UNITED STATES
DEPARTMENT OF THE INTERIOR
BUREAU OF LAND MANAGEMENT

SUNDRY NOTICES AND REPORTS ON WELLS
Do not use this form for proposals to drill or to re-enter an abandoned well. Use Form 3160-3 (APD) for such proposals.

EOG respectfully requests an amendment to our approved APD for this well to reflect the following changes:

Inga 33 Fed Com 513H (FKA Igor 33 Fed Com 501H) API #: 30-025-51720

Revised Wellbore A:

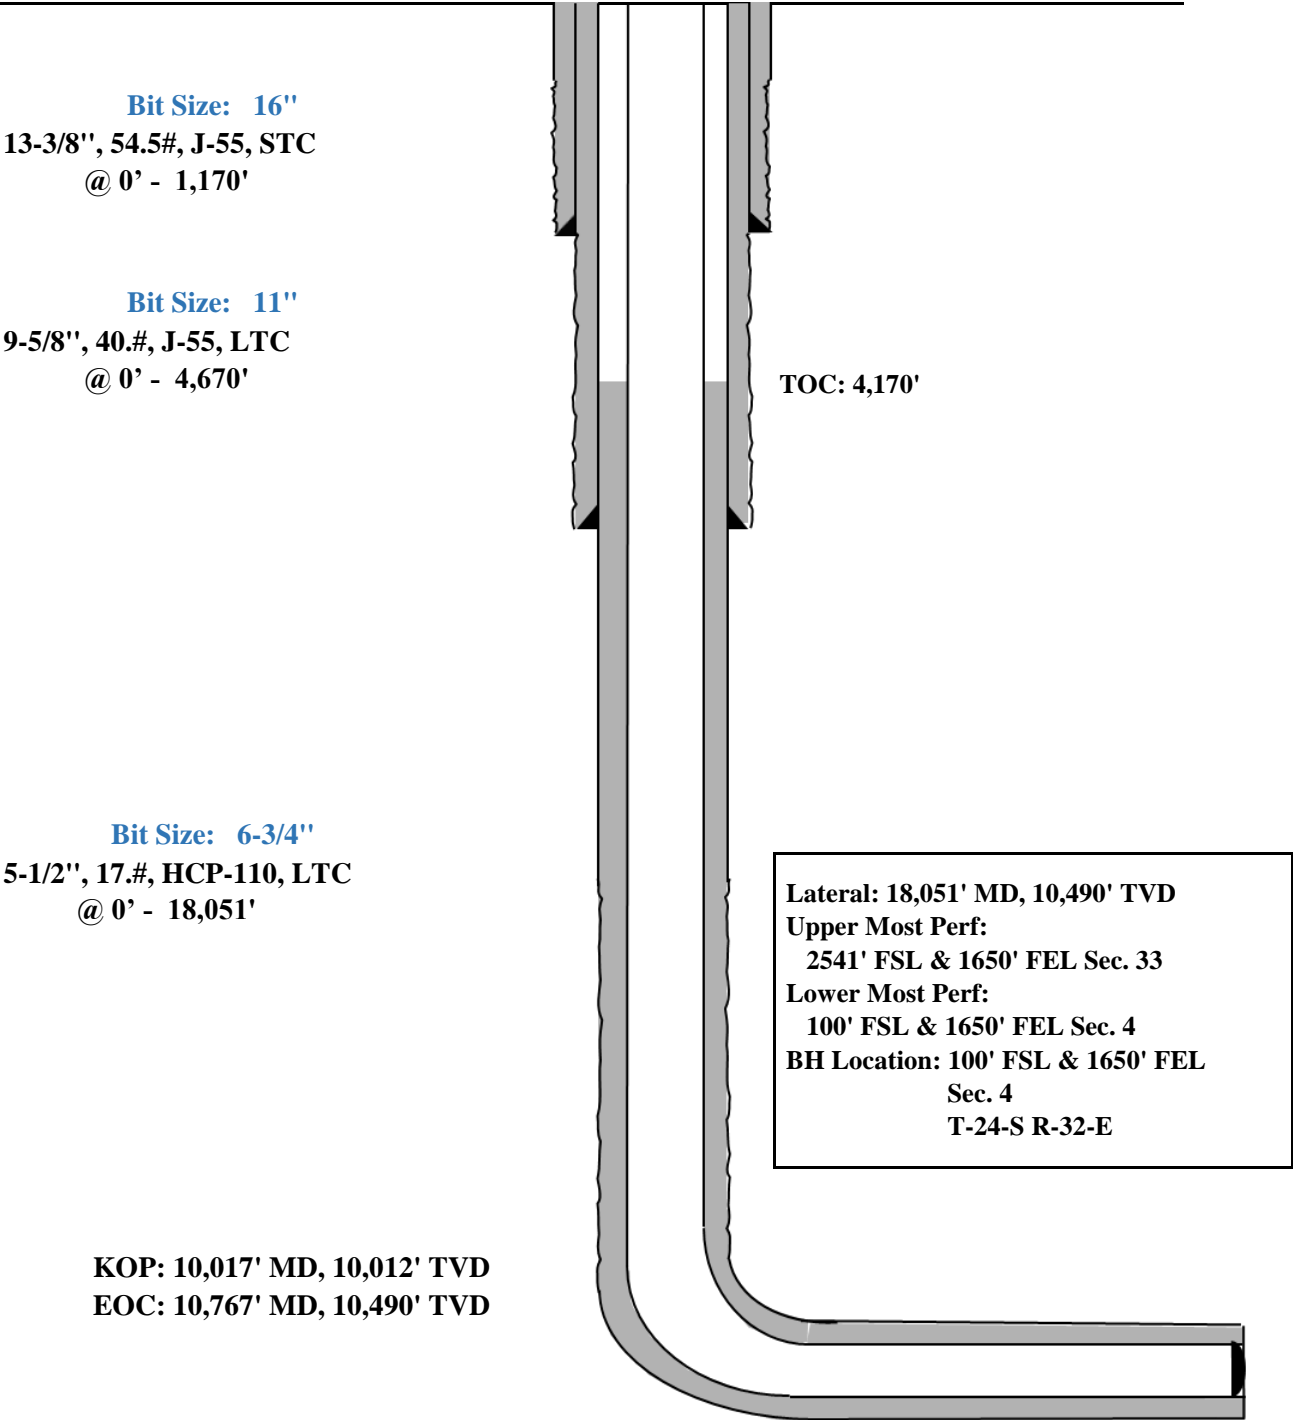
Casing Program A:

Hole Size	Interval MD		Interval TVD		Csg OD	Weight	Grade	Conn
	From (ft)	To (ft)	From (ft)	To (ft)				
16"	0	1,170	0	1,170	13-3/8"	54.5#	J-55	STC
11"	0	4,679	0	4,670	9-5/8"	40#	J-55	LTC
6-3/4"	0	18,051	0	10,490	5-1/2"	17#	HCP-110	LTC

Variance is requested to waive the centralizer requirements for the 9-5/8" casing in the 11" hole size. An expansion additive will be utilized, in the cement slurry, for the entire length of the 11" hole interval to maximize cement bond and zonal isolation.

Variance is also requested to waive any centralizer requirements for the 5-1/2" casing in the 6-3/4" hole size. An expansion additive will be utilized, in the cement slurry, for the entire length of the 6-3/4" hole interval to maximize cement bond and zonal isolation.

EOG requests permission to allow deviation from the 0.422" annulus clearance requirement for the intermediate (salt) section from Onshore Order #2 under the following conditions:

Proposed 11" Hole with 9.625" 40# J55/HCK55 LTC Casing

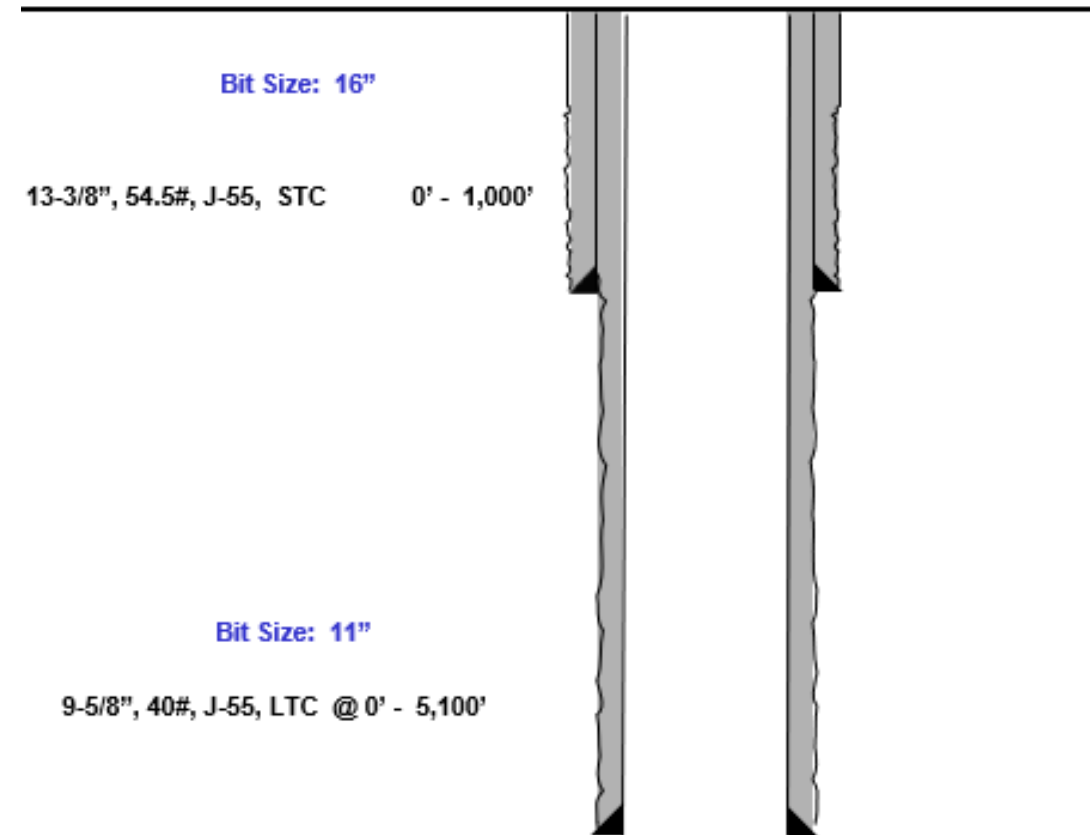
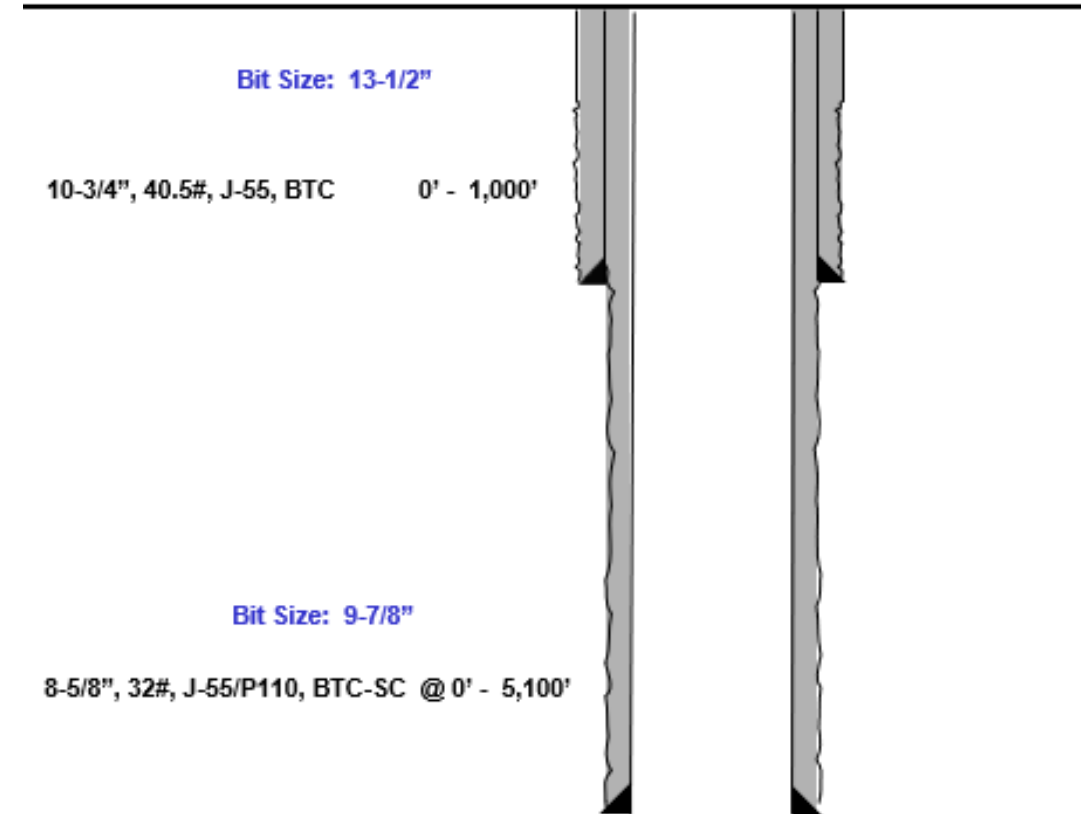
EOG request permission to allow deviation from the 0.422" annulus clearance requirement for the intermediate (salt) section from Onshore Order #2 under the following conditions:

- The variance is not applicable within the Potash Boundaries or Capitan Reef areas.
- Operator takes responsibility to get casing to set point in the event that the clearance causes stuck pipe issues

- 11" Bit + 0.52" Average hole enlargement = 11.52" Hole Size
 - 0.9475" Clearance to casing OD

$$= \frac{10.295 - 8.625}{2}$$
 - 0.585" Clearance to coupling OD

$$= \frac{10.295 - 9.125}{2}$$
- Previous Shoe – 10.75" 40.5# J55 STC
 - 0.4625" Clearance to coupling OD (~1,200' overlap)
